3m 79

Technical
Service
Bulletin

Professional Audio Service Bulletin

FIGURE 1

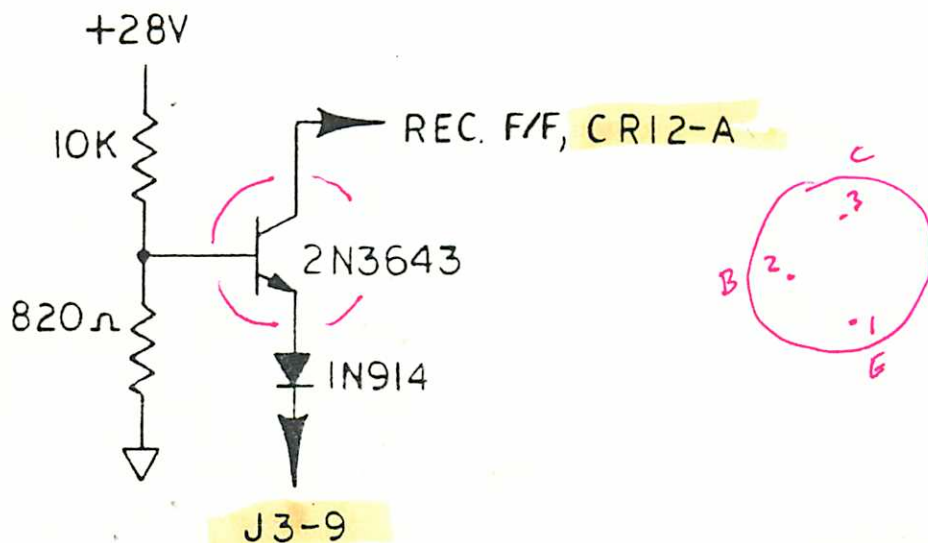
11. Remove Logic and Master Bias Supply board from rear of M79.
12. Add the circuit shown in Figure 1, below, to the Logic board.

- c. Fabricate circuit shown in Figure 1, above, on 3/4" x 1" perf board, using Figure 3, below, as a guide.

FIGURE 2

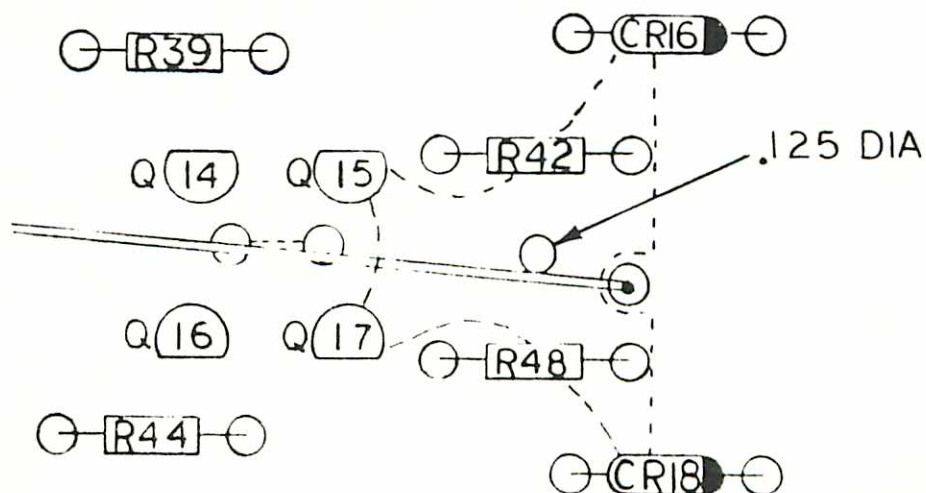
- a. Locate the ground plane between R42 and R48 (lower left quadrant of Logic board), on the rear side of board. See Figure 2, below.
- b. Drill .125 Dia. hole through ground plane, ensuring that hole does not cut any traces on component side of board. See Figure 2, below.

Figure 1

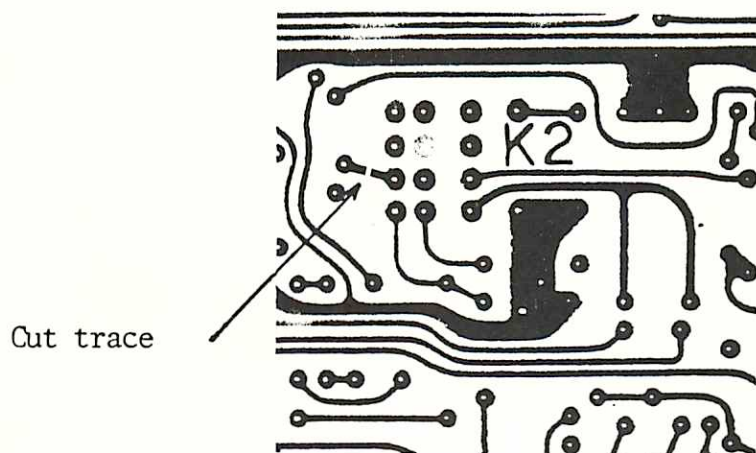
1. Remove power from the M-79.
2. Remove the logic board.
3. Cut the trace from K2-2 to J2-8. See Figure 1, below.

Fig. 4

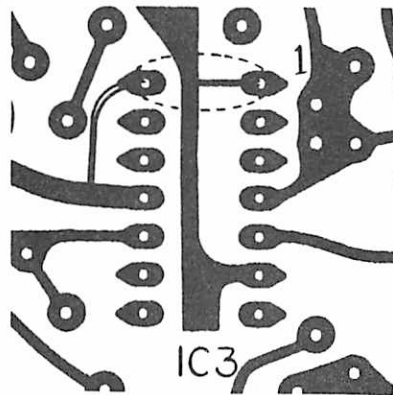
6. Using Mylar sleeving over cap leads; solder .02uF cap to traces from IC3 pins 6 and 11. See Figure 4, below.
7. Using Mylar sleeving over cap leads; solder .02uF cap to traces from IC4 pins 6 and 11. See Figure 5, below.

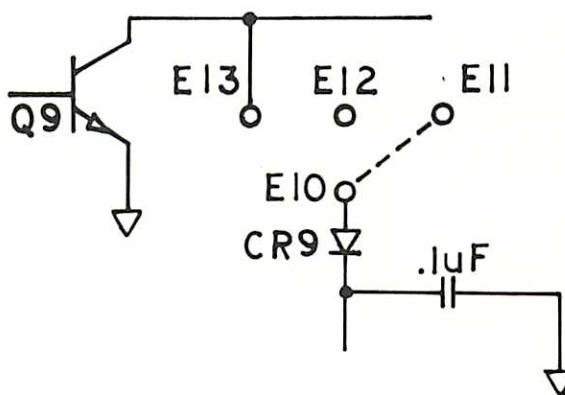
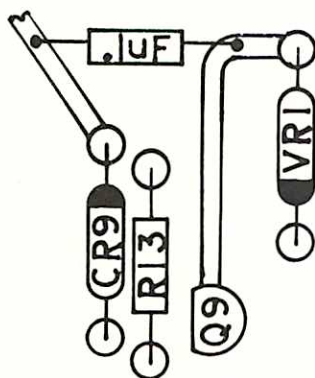
PROCEDURE: 1. Add Capacitor between the cathode of CR9 and the anode of VR1 (ground) as shown in figures below.

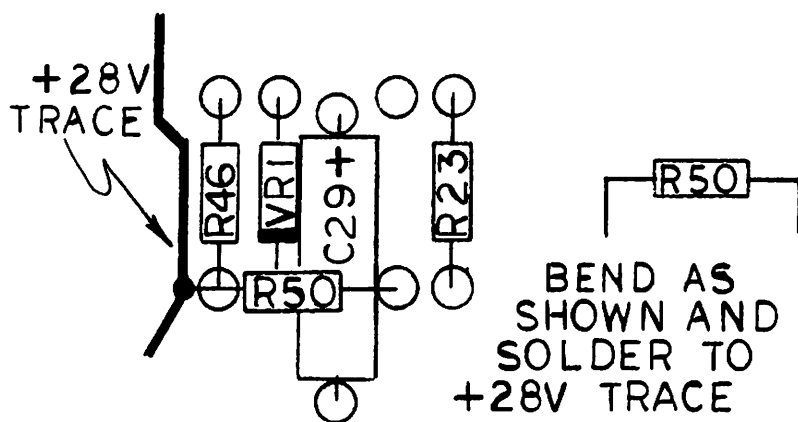
1. Remove R50.
2. Install 20K ohm resistor as shown in figure 1.

FIGURE 1

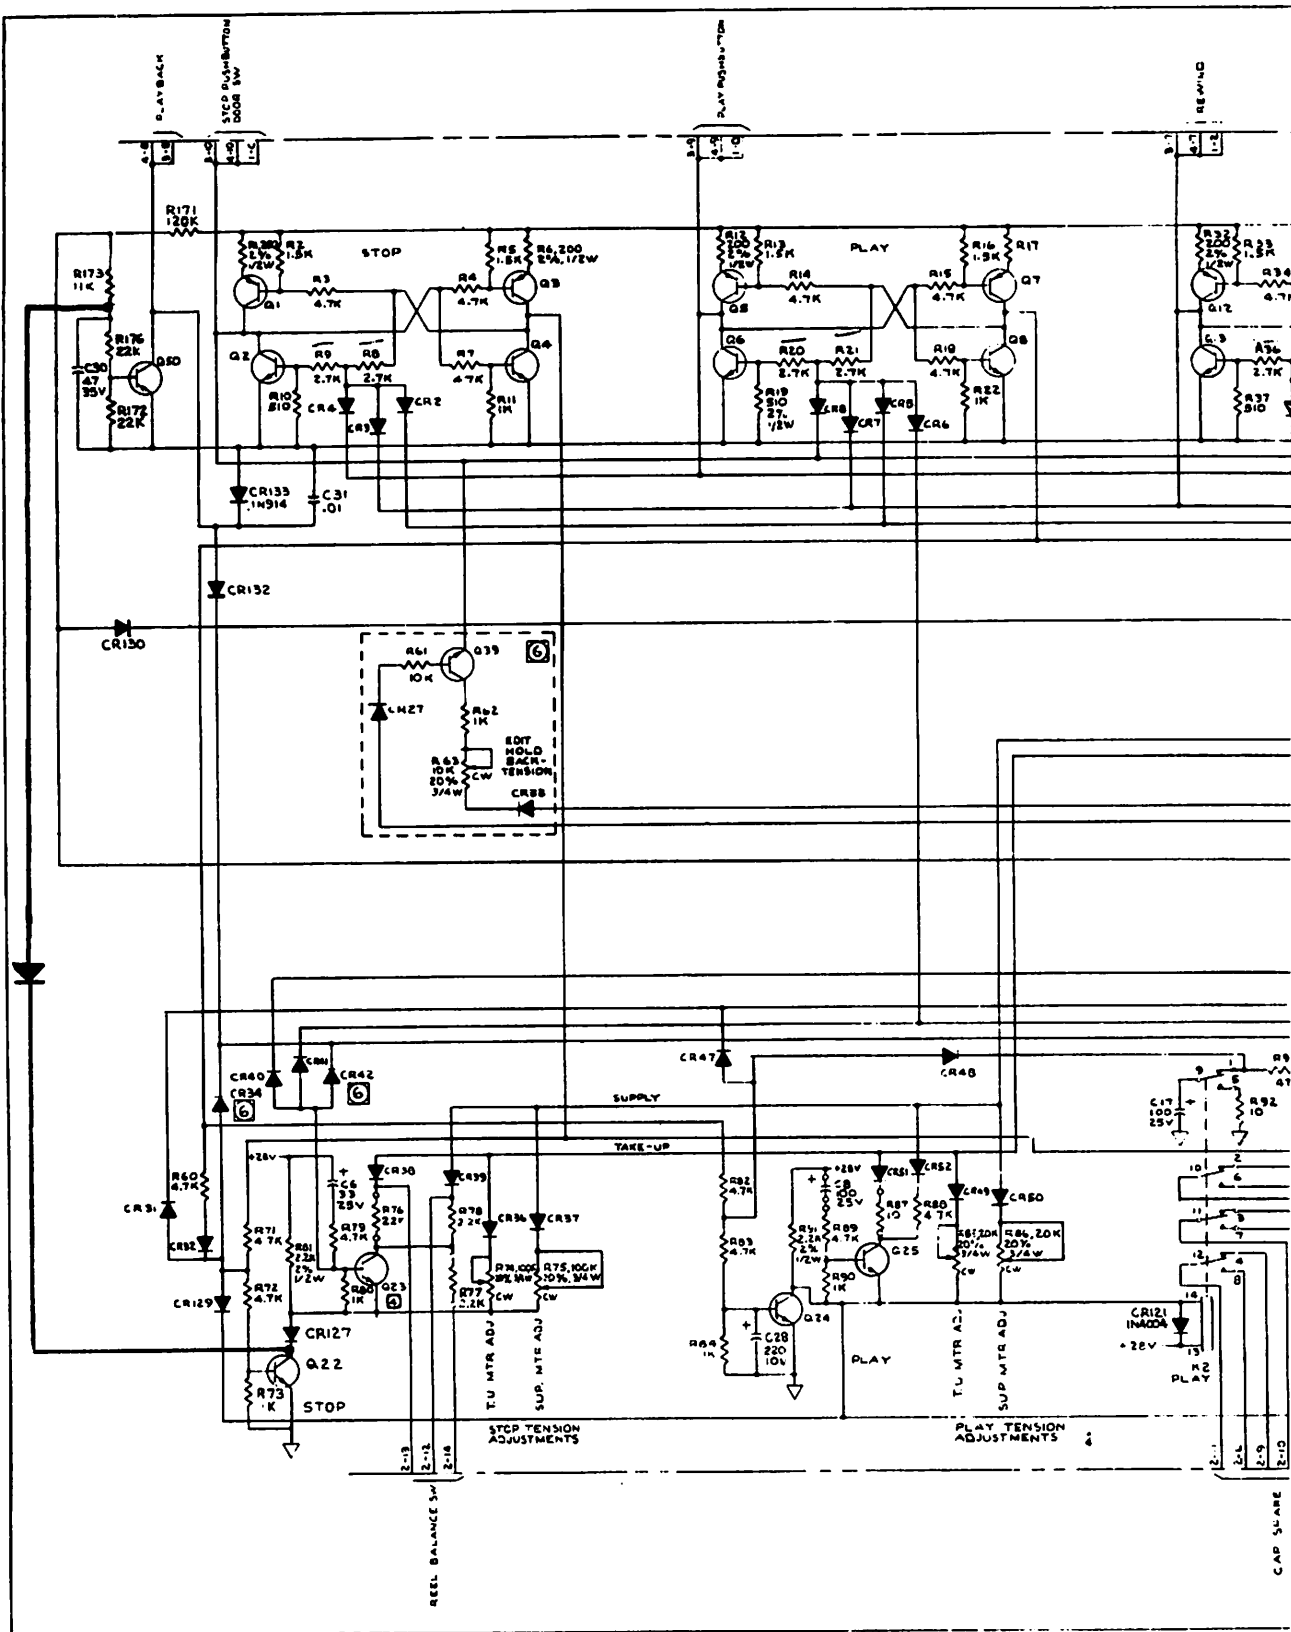
- 1) Remove logic pc Board from recorder.
- 2) Install 1N914 diode from collector of Q-22 to junction of R-173 and R-176. (cathode of diode to collector of Q-22) see Fig. 1. Use tubing on leads of diode.
- 3) Install logic pc board into recorder.
- 4) Thread a roll of tape onto the recorder which has a signal recorded on it and press stop button.
- 5) Manually move tape back and forth. Signal from tape should not be heard nor appear on meters.
- 6) Press mute defeat switch and repeat step five. Signal should be heard and should appear on meters.
- 7) This mod will not effect the monitoring of input signals.

FIGURE 2

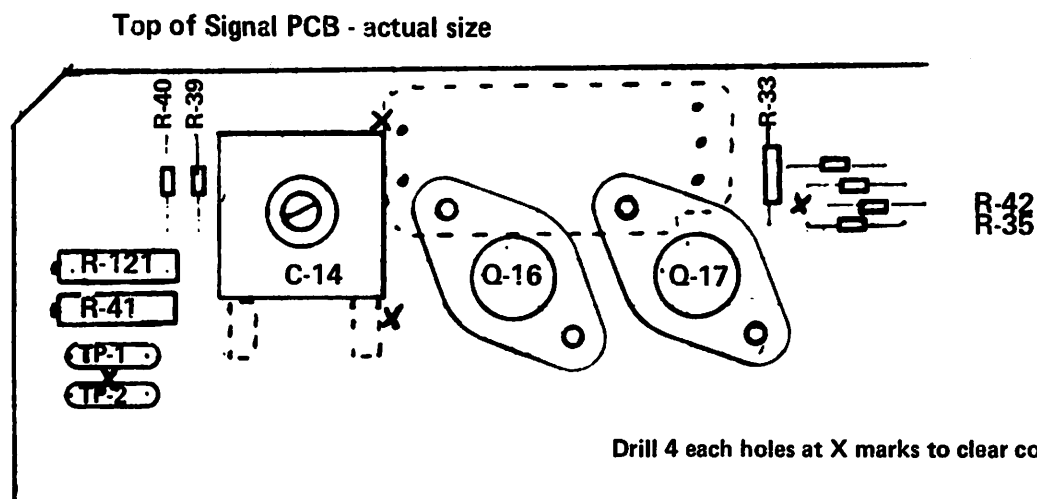
7. Locate same trace as in Step 5 and drill a hole into this trace between C-14 and Q-16 (see figure 1).
8. Mount relay K-A on a piece of perf board and mount the perf board to the mounting screws of Q-16 and Q-17 using two 6-32 nuts (see figures 1 and 2).

New Circuit Configuration

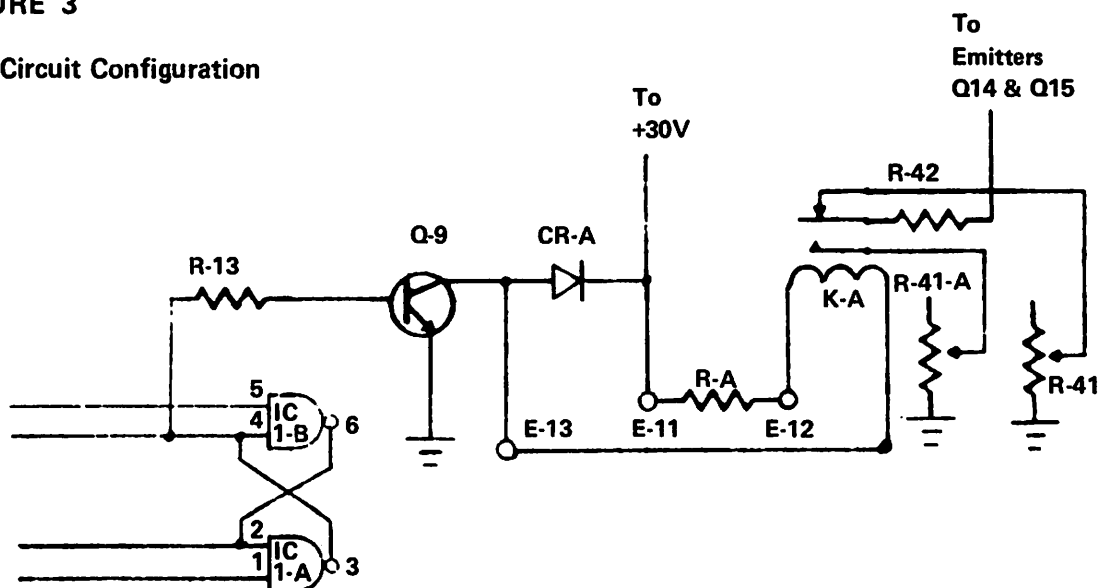
1. Remove Q-20, R-13, R-19, CR-9 and discard.
2. Remove any jumper connected to points E-10 through E-13.
3. Remove TP-2 (white) from board. Use care in not lifting pads from pc board (see figure 1).
4. R-41-A will be mounted in place of TP-2. Clip off rear lead of R-41-A. Drill a hole midway between and slightly above TP-2 mounting holes. This hole and forward most hole will be used to mount R-41-A (see figure 1).
5. Locate trace running from R-42 to wiper of R-41. Cut this trace about an inch from R-42.
6. Drill a hole behind bottom lead of C-14 (erase trimmer). Do not drill through any traces.

Figure 1

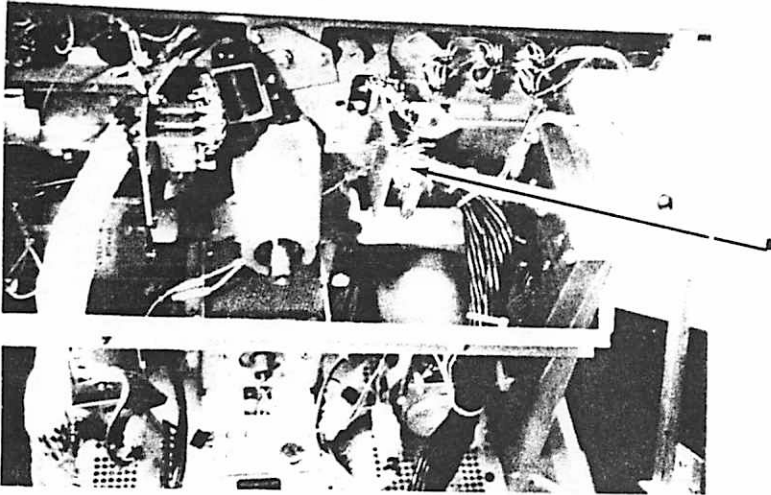
- b. Install new bracket assembly onto transport. (Figure 1)
 - c. Reconnect head connector(s). (Figure 2)
4. Repeat steps 2 and 3 above for bracket on record side.

Figure 3

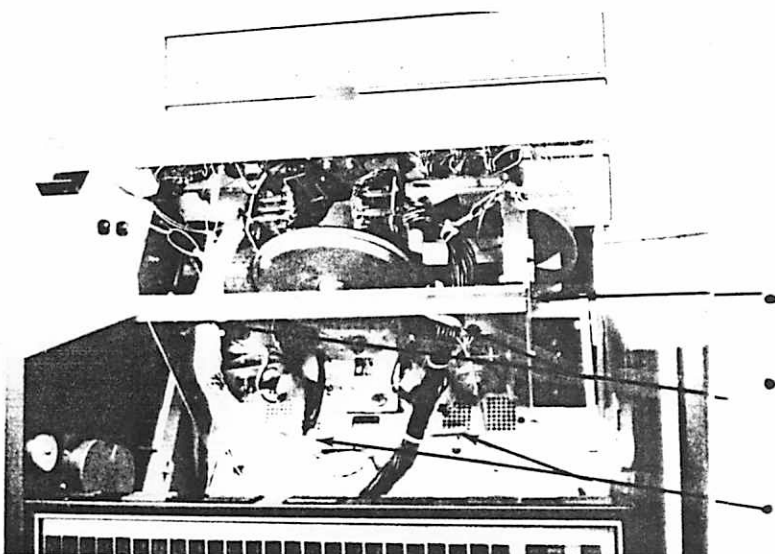
9. Reinstall capstan belt and refer to section 4-30 of the manual for belt tension adjustment.
10. Reinstall lower belt cover.
11. Install head cable mounting bracket 83-3320-2962 as shown (Figure 3). Use existing screw on right side, use 8-32 x 1/2" screw on left side.

12. Attach head cables to bracket using clamps removed in step 1f. Use 10-32 hardware furnished (Figure 3).
13. Install a spring from each head cable bundle to rear of transport wrap around (See Figure 3).

FIGURE 1

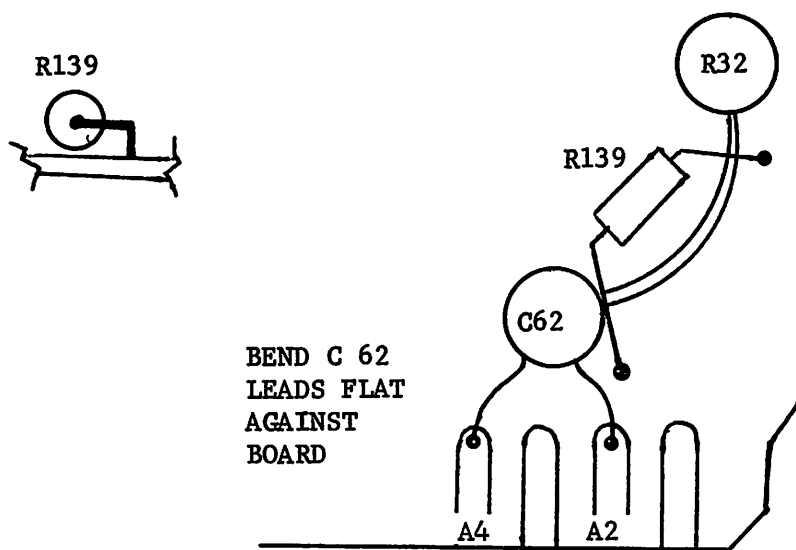
1. Drill four holes .041/.046 inches in diameter at points indicated on figure 1.

2. Cut the printed circuit trace as indicated on figure 1.
3. Install the capacitor, designated C-62 in the holes drilled in the finger contacts (see figure 2). Insure the leads lie flat against the board to prevent shorts to the board brace.
4. Install the resistor, designated R139, as indicated in figure 2. Bend the leads to make contact with the trace on the back of the board and solder. R-139 must be bent as shown to prevent accidental short circuits and to permit the board to be installed in the Recorder.
5. Change Instruction Manual schematics (see figure 3) and parts list to reflect C-62 and R-139.

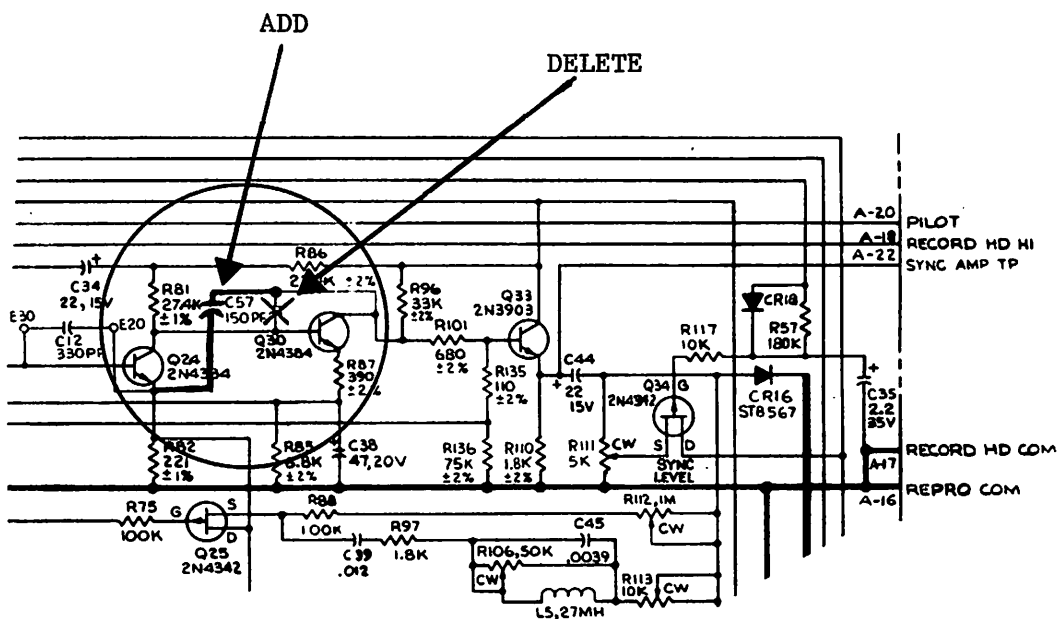
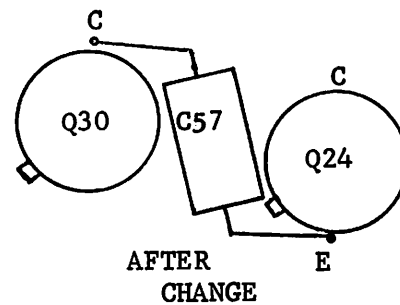
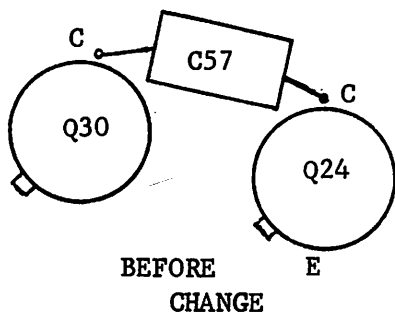
1. Remove Capacitor C-57 which is connected between the collectors of Q-30 and Q-24 (see figure 1).
2. Drill one hole using a .030/.035 inches, drill adjacent to the emitter connection of Q-24 (see figure 2).

3. Install the new 560pf capacitor, designated C-57, between the collector of Q-30 and the emitter of Q-24 (see figure 2). Insert capacitor lead through new hole, then bend the lead to the emitter trace of Q-24, then solder.
4. Check Recorder alignment and adjust if necessary.
5. Change Instruction Manual schematics and parts list to reflect the new location of C-57 as indicated by figure 3.

FIGURE 1

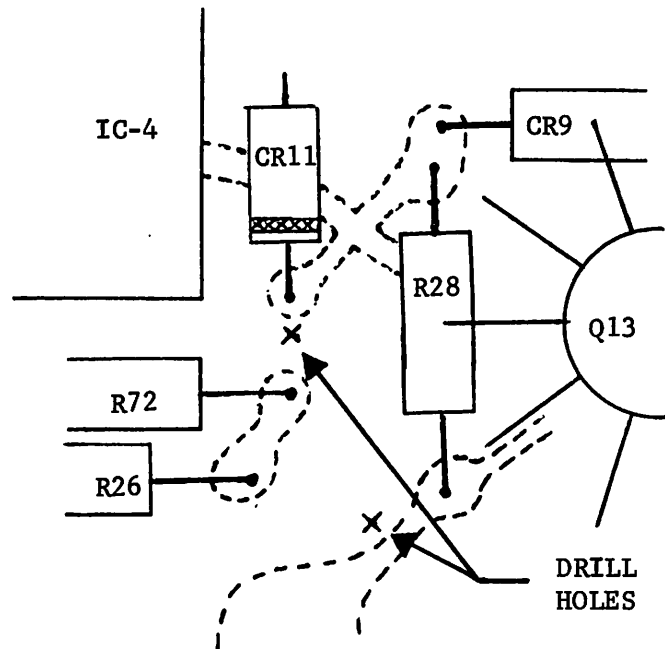
1. Drill two holes .030/.035 inches in diameter at points in figure 1.

2. Install the .001 μ f capacitor (designated C61) by inserting leads through new holes, bend leads to touch adjacent traces, then solder.
3. Check Recorder alignment and adjust if necessary.
4. Change Instruction Manual schematics (see figure 2) and parts list to reflect the new capacitor, C-61.

Correct Positions
FIGURE 1

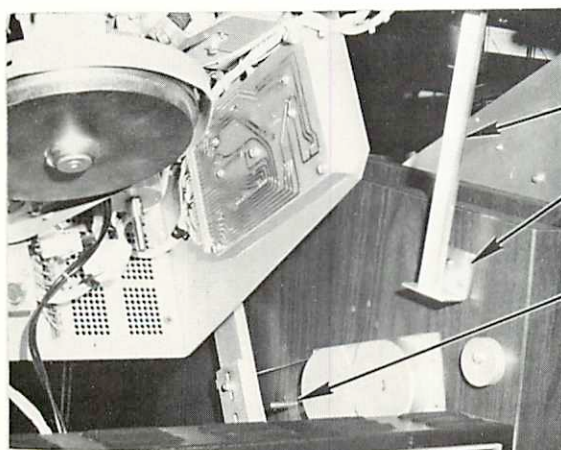
1. Raise the tape transport and observe the position of the support bracket and the stop post. If they appear as in figure 1, proceed with step 3. If they appear as in figure 2, proceed with step 2.

FIGURE 3

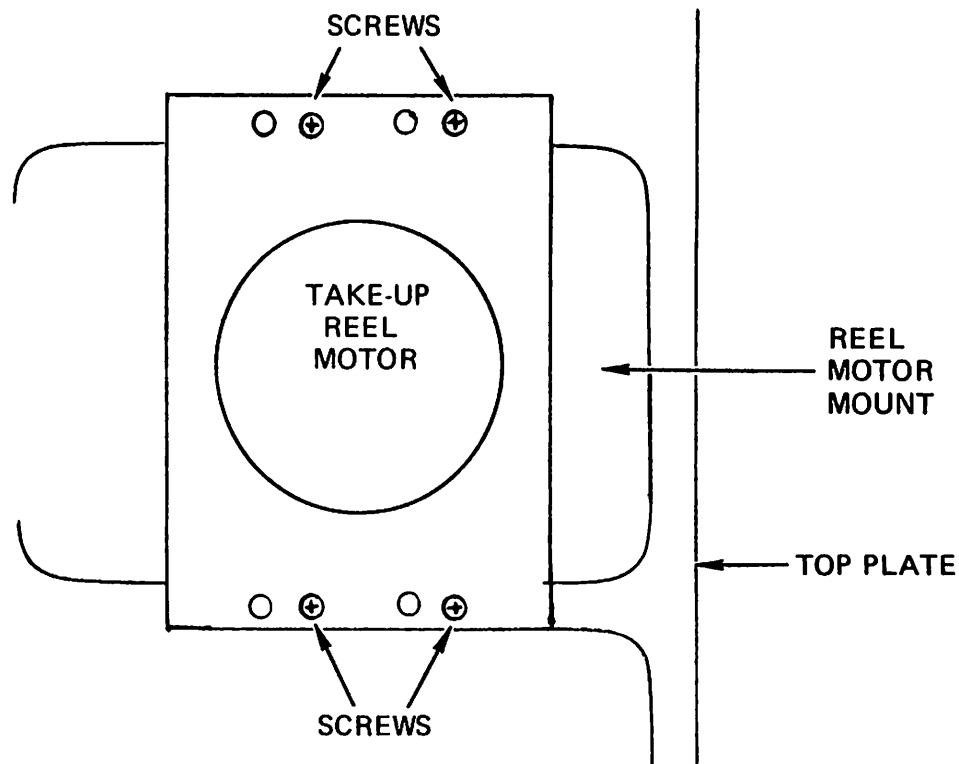
2. Modify the recorder to match figure 1 as follows:
 - a. Relocate support bracket using the template (figure 5) to locate the holes to be drilled.
 - b. Relocate the stop post so it is centered approximately 1 inch behind the pulley (see figure 1) by drilling a 1/4 inch hole and glueing in post.
 - c. Remove existing arm and replace it with a new 11 inch arm (part of conversion kit).
3. Disconnect supply and take-up motor connectors from wiring connectors; remove the four (4) screws holding each reel motor mounting plate and remove motor assembly (see figure 3).
4. Install motors on new motor mounting brackets (supplied in kit).
5. Install reel motor assemblies on recorder top plate (see figure 4). Install harness assemblies (supplied with kit) between respective motor assembly connector and wiring connectors.
6. Install new tape transport cover (supplied with kit).
